Access Compliance Report

Public Rights-of-Way

(Curb Ramps)

Intersection ID: N/A	Main Street: STRAWBERRY_FIELDS_LN	Cross Street: MAGGIE_MAY_LN	Location: W
ADA ID: 82B76BAAD2FE	Ramp Type: Perp	Initial Pass/Fail: Fail	Overall Compliance: No
Severity Score: 8.75			
Codes/Mitigation Info/Possible Solution		Field Measurements/Component Compliance

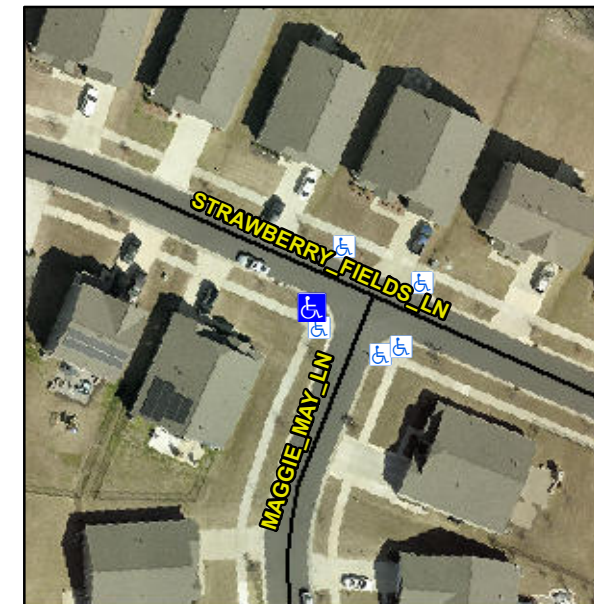
R304.5.1

Compliance	Description	Data	Compliance	Description	Data
N/A	Ramp Length (in)	98.5	Yes	Ramp Slope (%)	6.5
No	Ramp Width (in)	46.0	Yes	Ramp XSlope (%)	1.5
N/A	Flare Type LT	N/A	N/A	Flare Type RT	N/A
N/A	Flare Slope LT (%)	N/A	N/A	Flare Slope RT (%)	N/A
N/A	Flare Traversable LT?	N/A	N/A	Flare Traversable RT?	N/A
N/A	Landing Length (in)	N/A	N/A	DWS Provided?	N/A
N/A	Landing Width (in)	N/A	N/A	DWS Contrast?	N/A
N/A	Landing Slope (%)	N/A	N/A	DWS Length (in)	N/A
N/A	Landing X Slope (%)	N/A	N/A	DWS Full Width?	N/A
N/A	Landing Curb? (Y/N)	N/A	N/A	DWS Offset (in)	N/A
N/A	Shared Landing?	N/A			
N/A	Gutter Ponding?	N/A	N/A	Gutter Slope (%)	N/A
N/A	Gutter Lip Ht (in)	N/A	N/A	Gutter X Slope (%)	N/A
N/A	Painted X Walk1?	No	N/A	Painted X Walk2?	N/A
	X Walk 1 Direction	To NE		X Walk 2 Direction	N/A
N/A	X Walk 1 Width (in)	N/A	N/A	X Walk 2 Width (in)	N/A
	X Walk 1 Slope (%)	1.9		X Walk 2 Slope (%)	N/A
	X Walk 1 X Slope (%)	2.0		X Walk 2 X Slope (%)	N/A

Remove & Replace Entire Ramp.
